**Notice of Allowability**

10/534,008

VAN BERKEL, CORNELIS

FIG.1

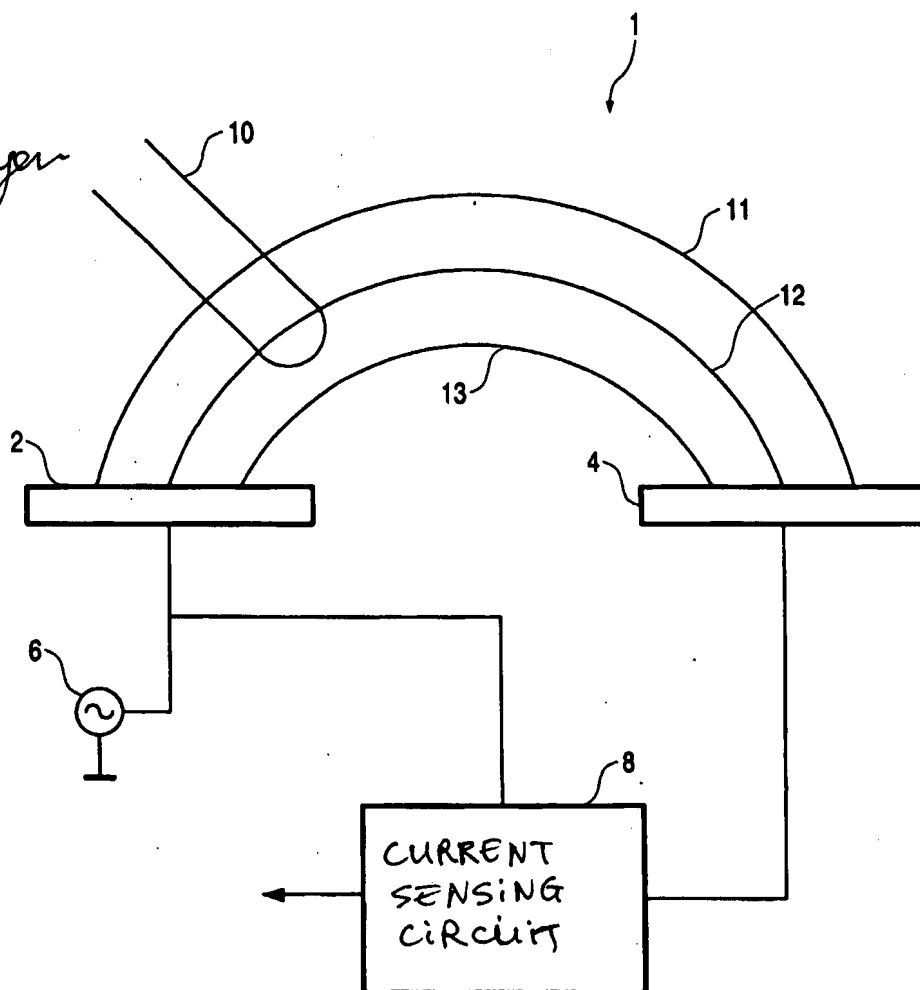
In the drawing of figure 1, box # 8 is labeled – Current Sensing Circuit –

FIG.2

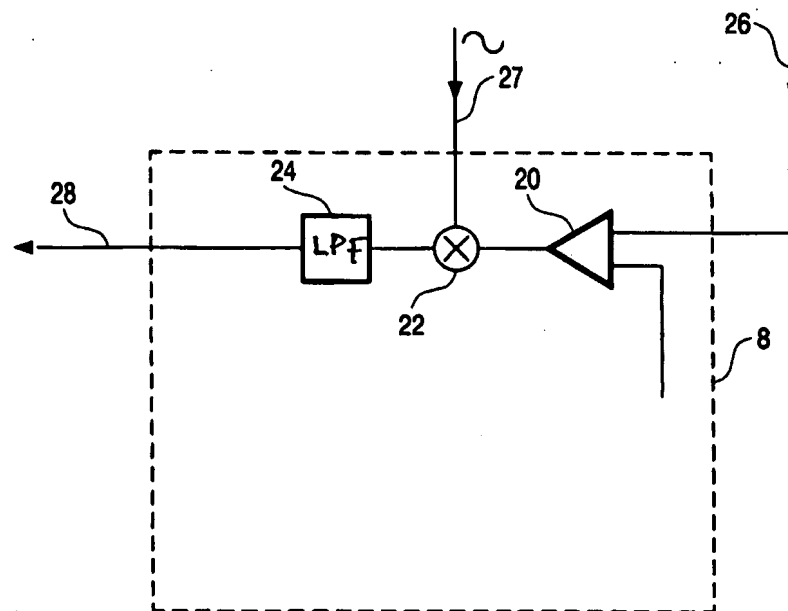
In the drawing of figure 2, box # 24 is labeled – LPF –

FIG.4

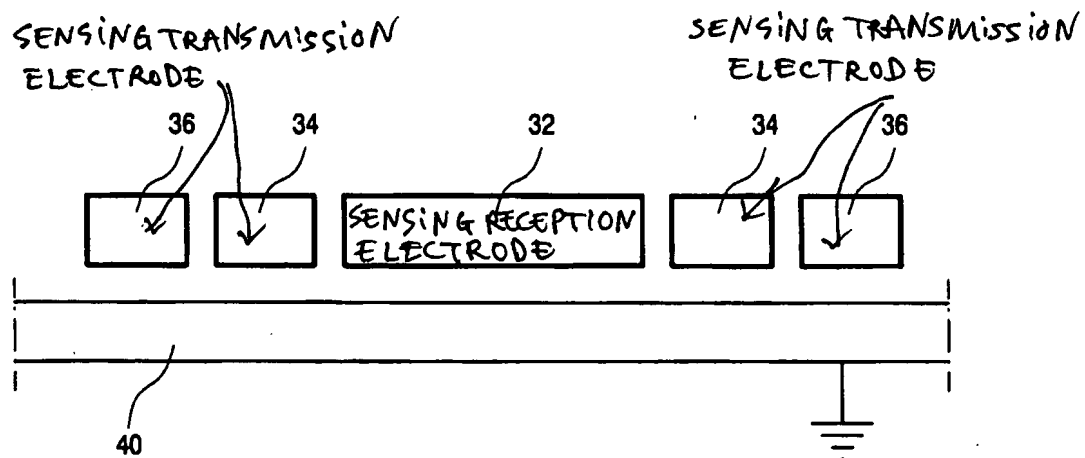
In the drawing of figure 4, box # 32 is labeled – Sensing Reception Electrode -- ;  
boxes 34 and 36, are labeled – Sensing transmission Electrode –

FIG. 5

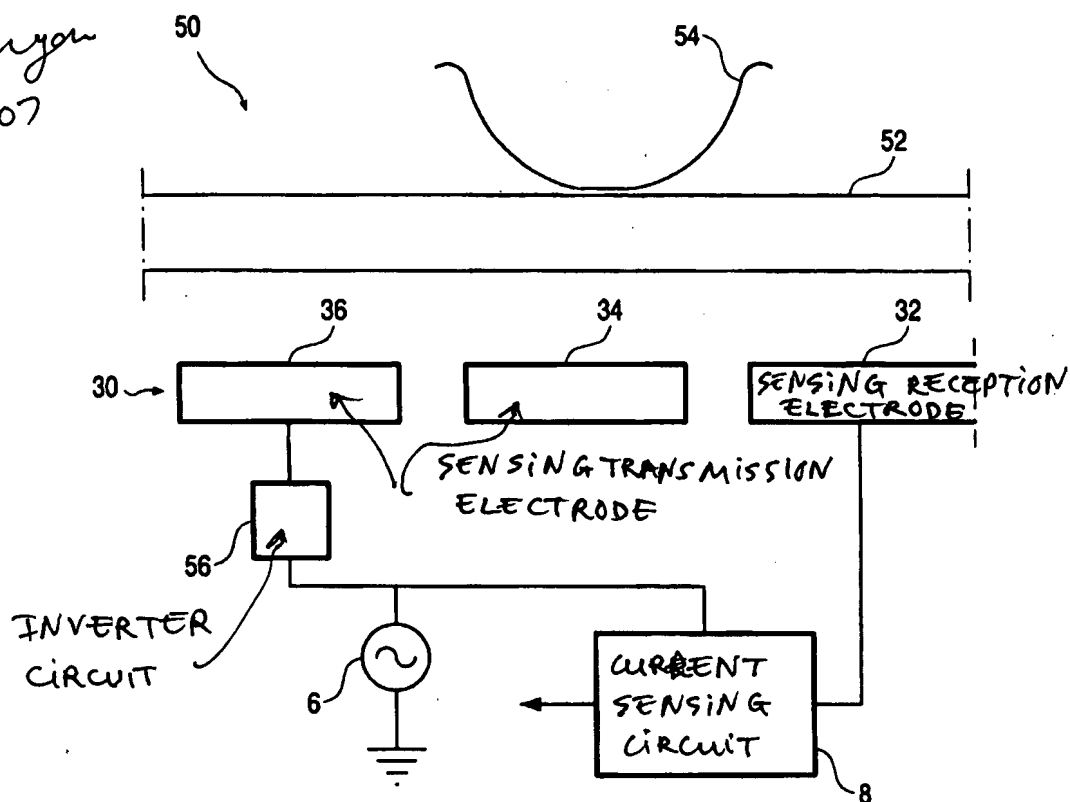
In the drawing of figure 5, box # 8 is labeled – Current Sensing Circuit --; box #  
32 is labeled – Sensing Reception Electrode --; boxes # 34 and 36 are labeled –  
Sensing Transmission Electrode –
